Proposed Milton Quarry East Extension
JART COMMENT SUMMARY TABLE – Geology and Water Resources

JART Comments (December, 2022)	Reference	Source of Comment	Applicant Response (January 2023)	JART Response
Report/Date: Geology and Water Resources Assessment Report December 2021		Author: GHD

AMP Addendum Figure 4Rev1 and Figure 5Rev1

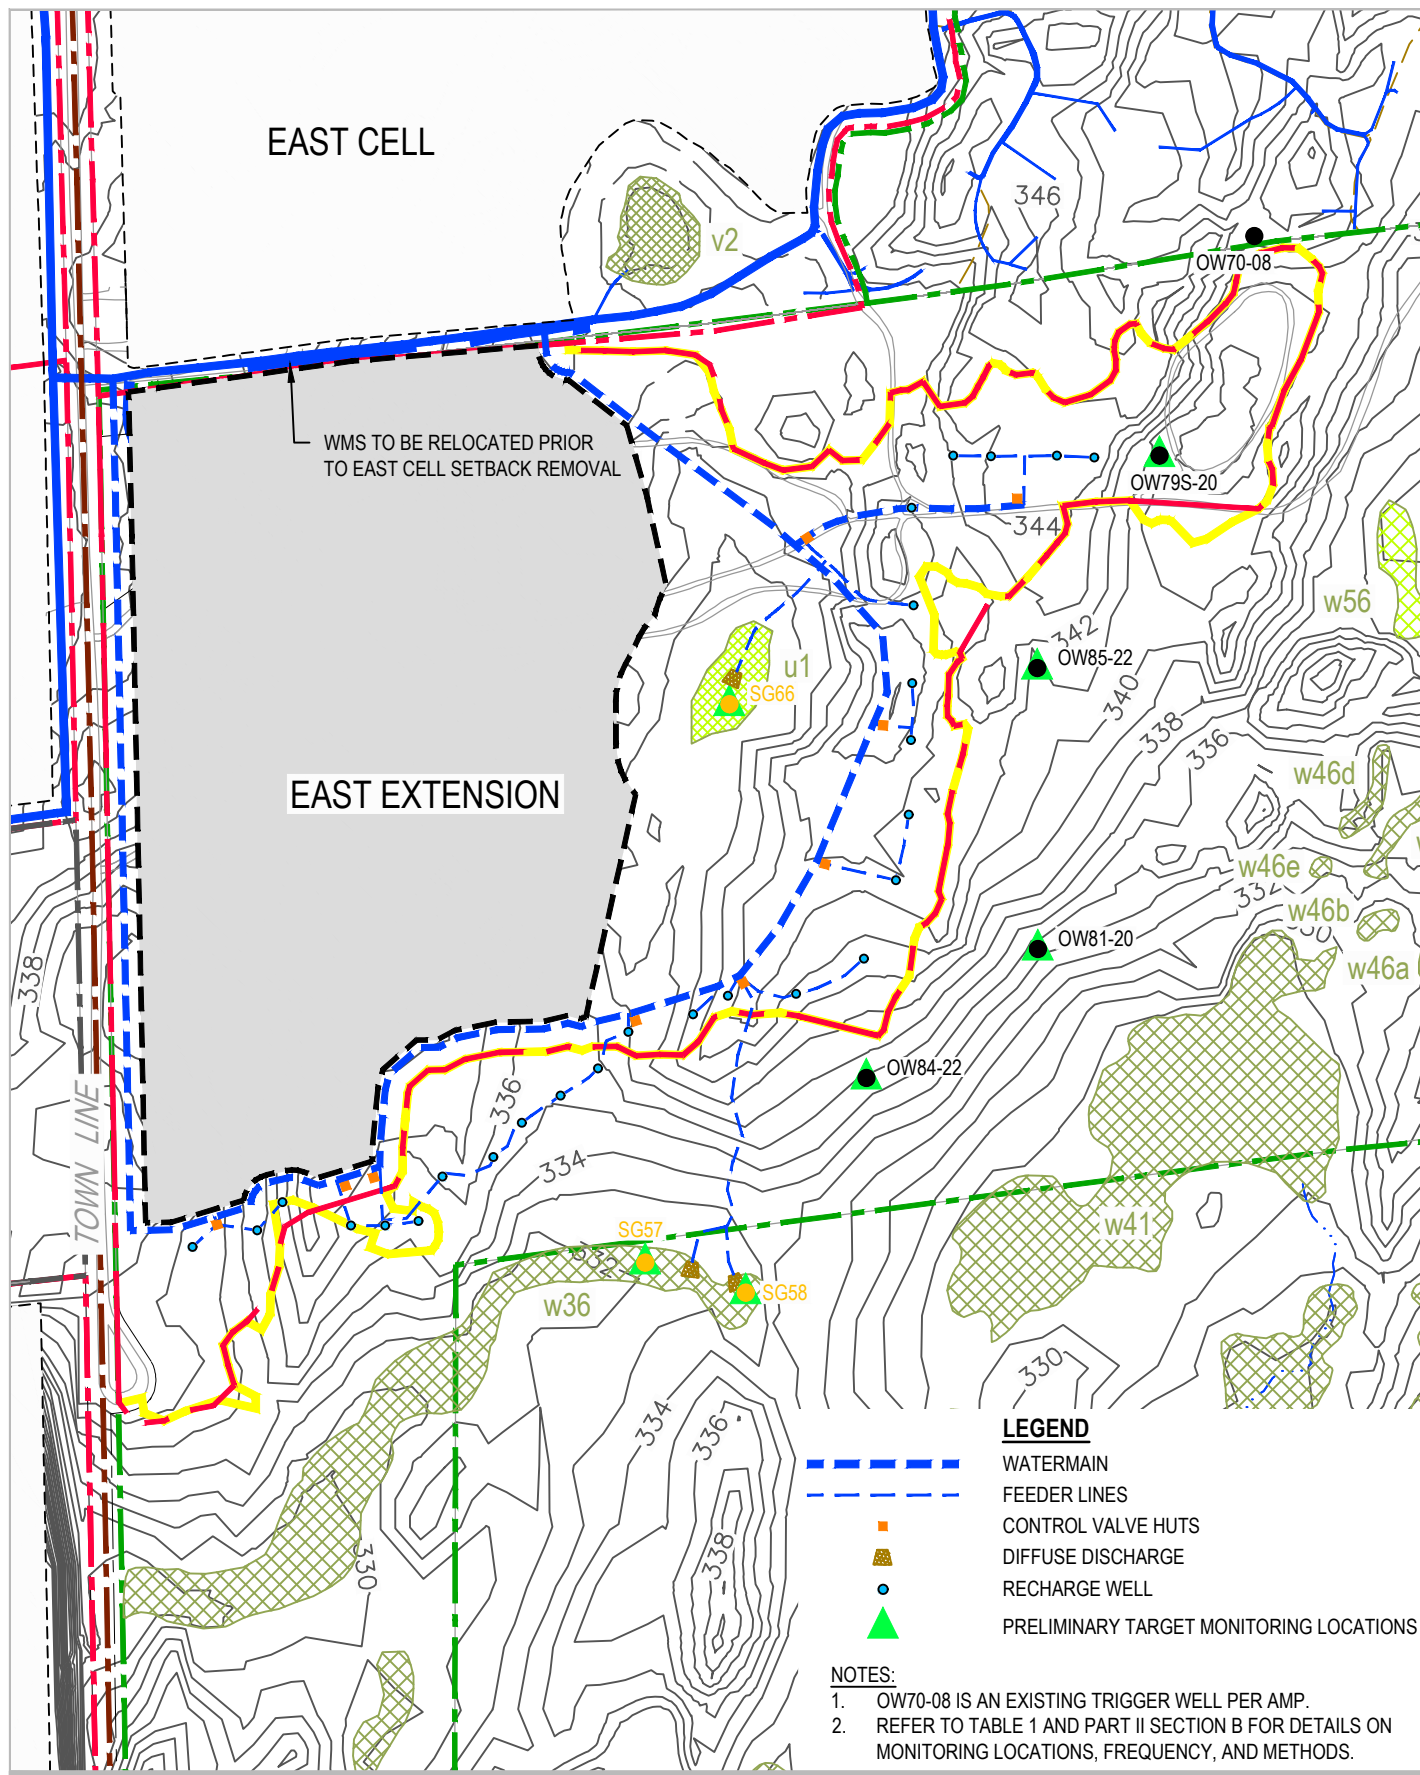
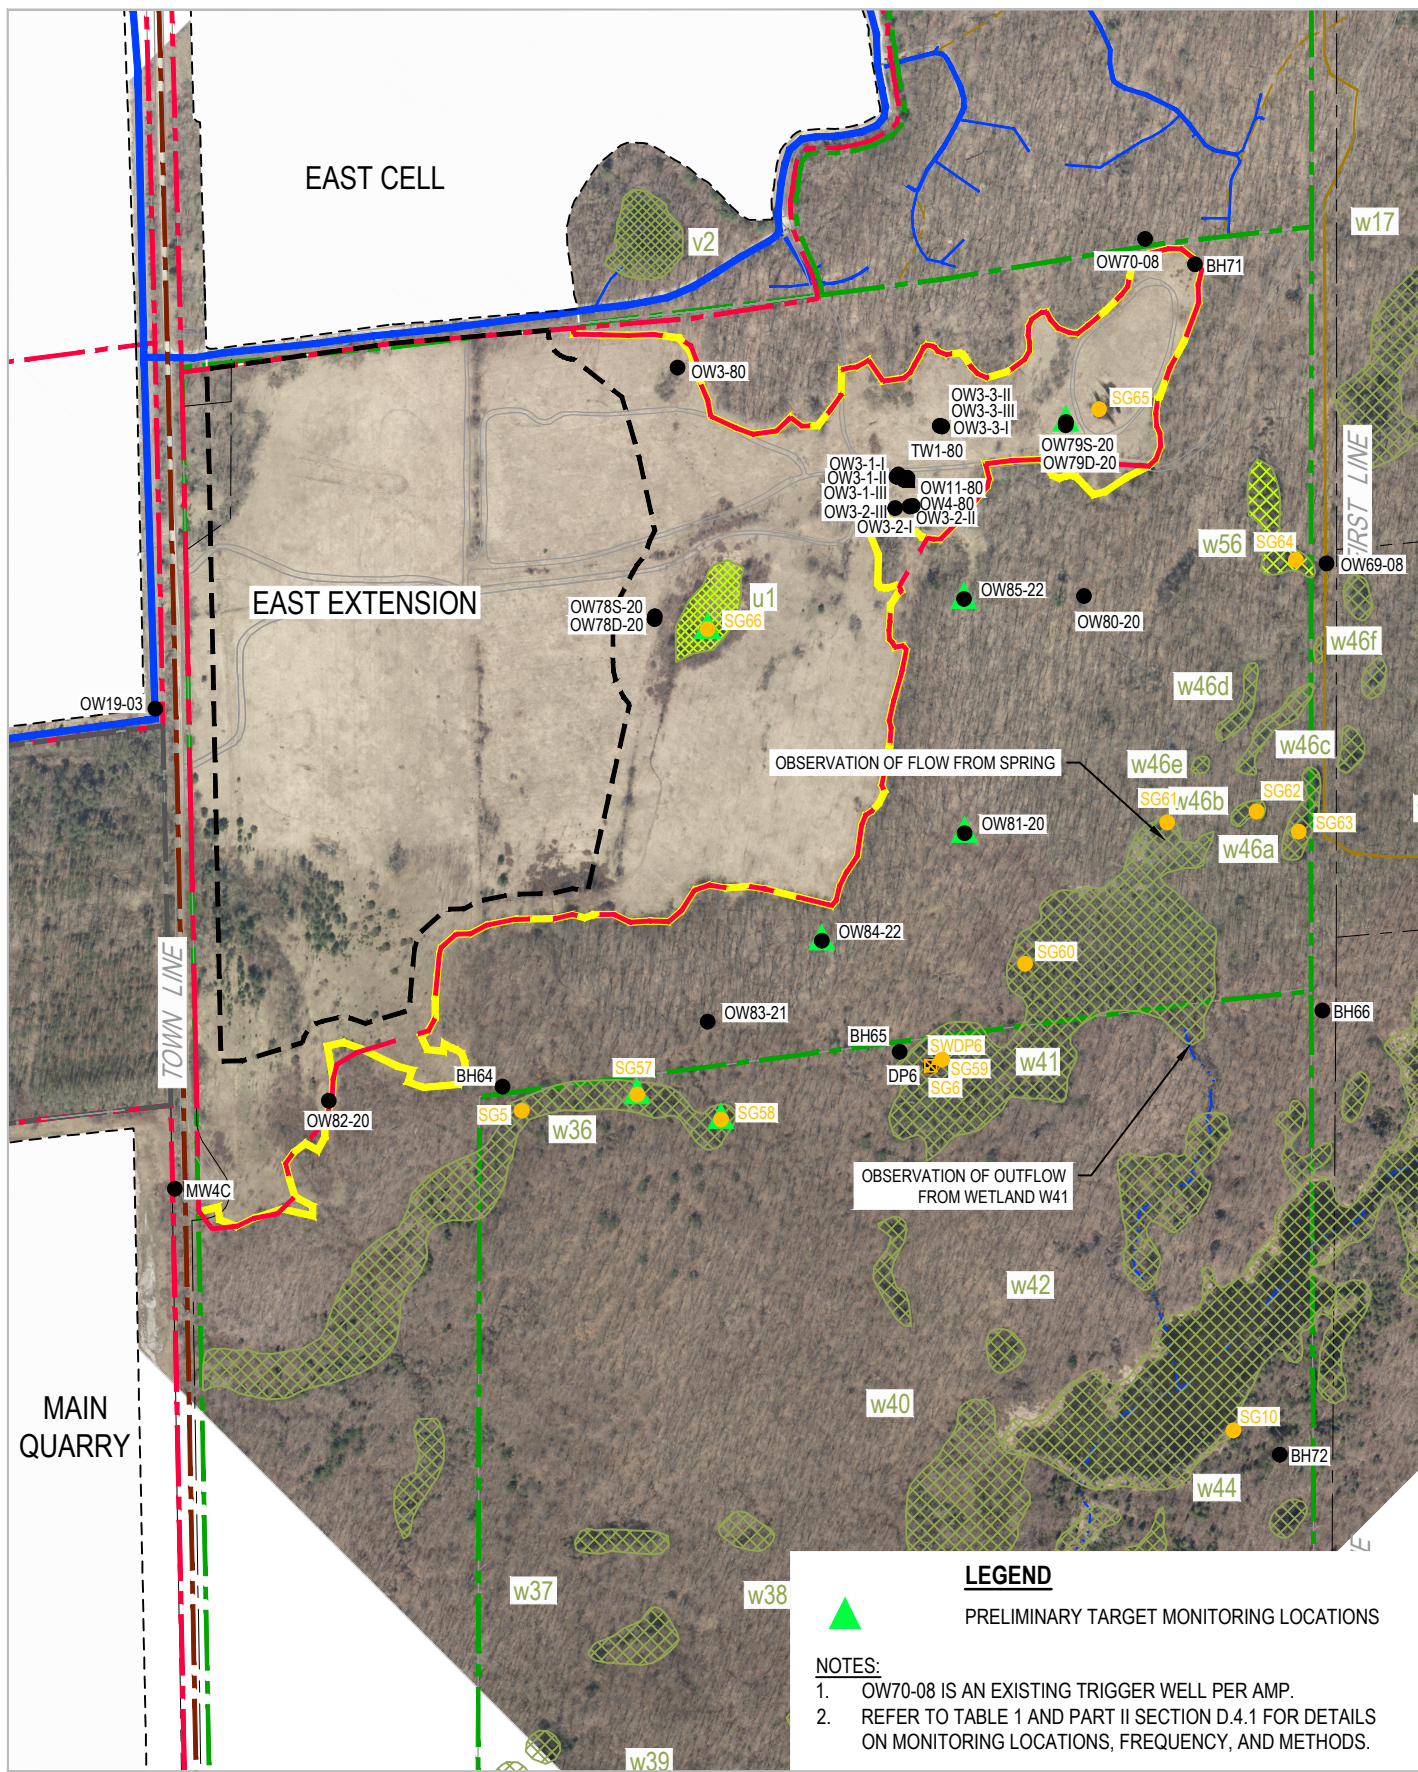
34.	<p>Monitoring well BH66, although useful is not representative of groundwater conditions for W41 nor W46. BH66 is located close to a 3 to 4 metre drop in ground surface at the bottom of which there is a series of wetlands. This drop is most likely responsible for lower groundwater levels in BH66. BH66 is also a considerable distance from wetlands W41 and W46.</p> <p>A groundwater monitor should be constructed on the upstream end of W41 and in the vicinity of W46 and incorporated into the monitoring program.</p> <p>To ensure wetland hydroperiod is maintained trigger levels for W46 should be set and mitigation actions and/or measures proposed.</p>	<p>Section 6.8.3 Wetland 41 and Wetland 46, page 40</p>	CH	<p>It is correct that BH66 is not in a suitable location for use as a Trigger Well. The AMP Addendum identifies that BH66 will be monitored as part of the Supplemental Monitoring network, not as a Trigger Well in the Performance Monitoring network.</p> <p>The AMP Addendum proposes Trigger wells on the upgradient (northwest) side of Wetland W41 and Wetland W46 as recommended in the comment. Figure 4 of the AMP Addendum identifies monitoring wells OW80-20, OW81-20, and OW83.21 as trigger wells (labelled “preliminary target monitoring locations” in the legend).</p> <p>In 2022 the proposed trigger well location network was optimized by the installation of two new monitoring wells (OW84-22 and OW85-22). With these additions, the trigger well network for the MQEE is now proposed to be comprised of monitoring wells (from north to south) OW79S-20, OW85-22, OW81-20, and OW84-22, as illustrated on AMP Addendum Figure 4Rev1 included in</p>

JART Comments (December, 2022)	Reference	Source of Comment	Applicant Response (January 2023)	JART Response
Report/Date: Geology and Water Resources Assessment Report December 2021			Author: GHD		
				Attachment C, hereto. Monitoring wells OW80-20 and OW83-21 will be retained as Supplemental Monitoring wells, as shown on revised AMP Addendum Figure 5Rev1, also included in Attachment C.
